Product Equality Declaration

We: FAMOCO SAS, declare on our sole responsibility the differences between the hardware revision of **NFC Android Validator** products.

Differences between **NFC Android Validator** hardware revisions FX925F,1 and FX925F-P are listed below.

Figure 1: Back Casing Pole – NFC Android Validator

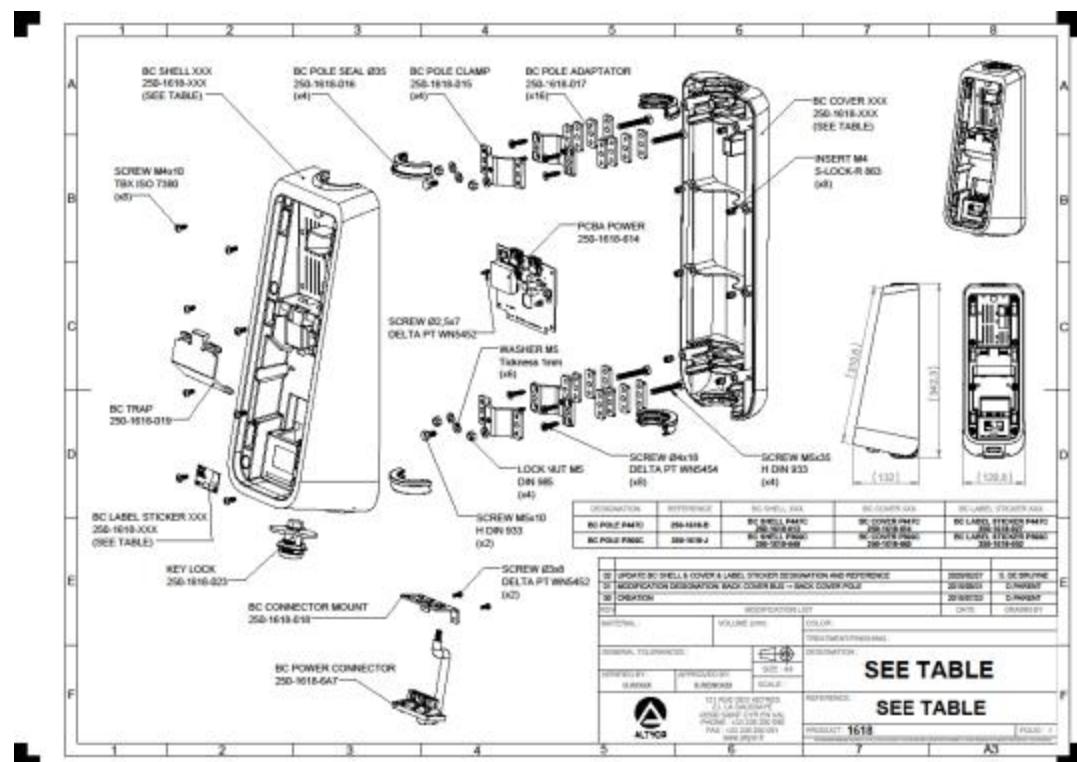
Table 4: List of differences between the NFC Android Validator Back Casing Pole BC-VPDC-P366C,4 and BC-VPDC-P366C,4:

#	Differences	NFC Android Validator BC-VPDC-P366C,2	NFC Android Validator BC-VPDC-P366C,4
#1	PCBA PWR	<ul style="list-style-type: none"> • PCBA PWR V18 with ferrites on cables 	<ul style="list-style-type: none"> • PCBA PWR V07

Figure 2: Back Casing Wall – NFC Android Validator

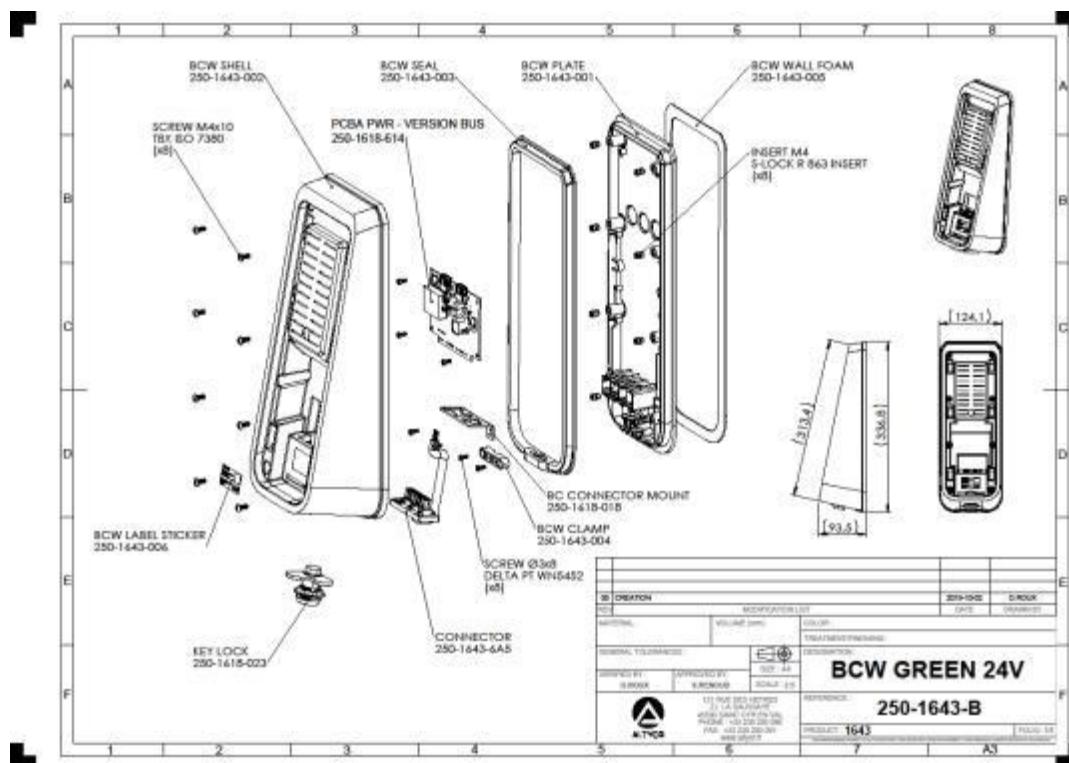
Table 3: List of differences between the NFC Android Validator Back Casings Wall BC-VWDC-P366C,2 and BC-VWDC-P366C,4:

#	Differences	NFC Android Validator BC-VWDC-P366C,2	NFC Android Validator BC-VWDC-P366C,4
#1	PCBA POWER	<ul style="list-style-type: none"> • PCBA PWR V18 with ferrites on cables 	<ul style="list-style-type: none"> • PCBA PWR V07
